NOPOWER & pd_undefined D2.4 v131

Info (not part of baseline)

Figure 145–26—Single-signature PD state diagram (continued)

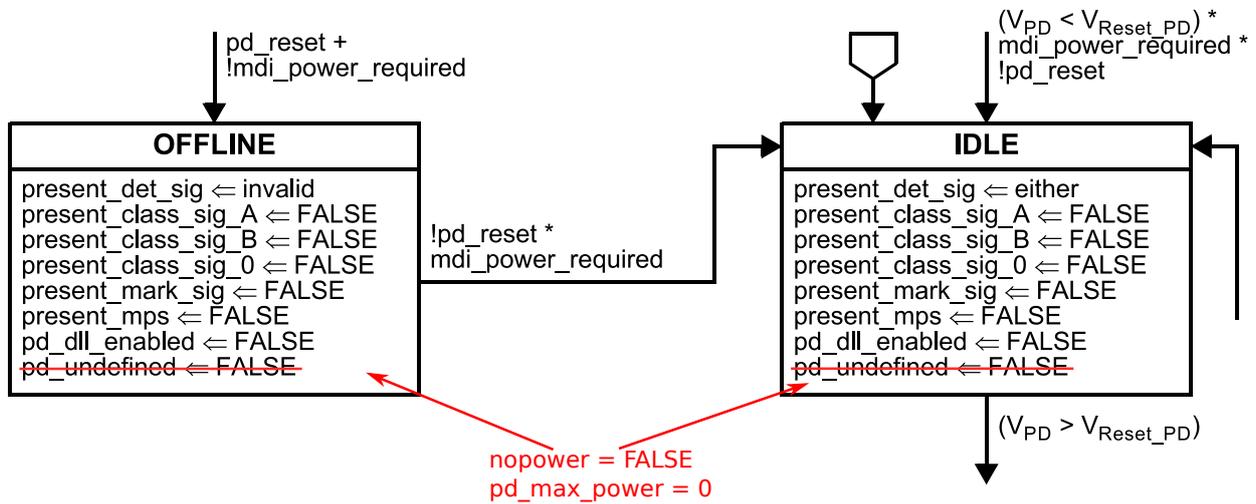
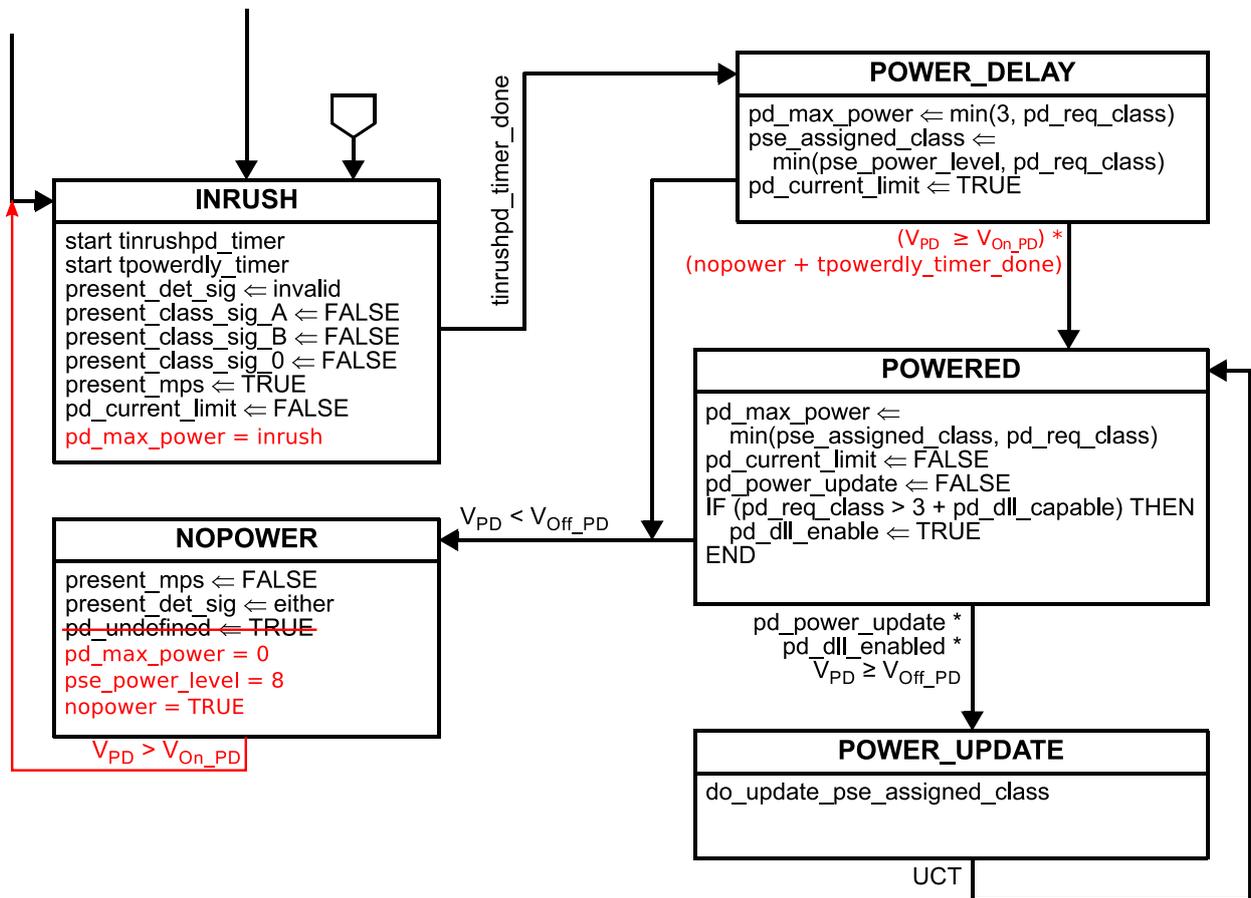
A return path from NOPOWER to INRUSH is added to transition back into defined operation. The `pse_power_level` variable is set to 8 in the NOPOWER state, this accounts for any class event count increase that may have happened. During NOPOWER, the `pd_max_power` variable is set to zero, restriction to PD to draw no more than 51mA. This is consistent with V_{Off_PD} requirements, but still allows the PD to draw mark, or class, or MPS.

Make changes to Figure 145–26 as follows:
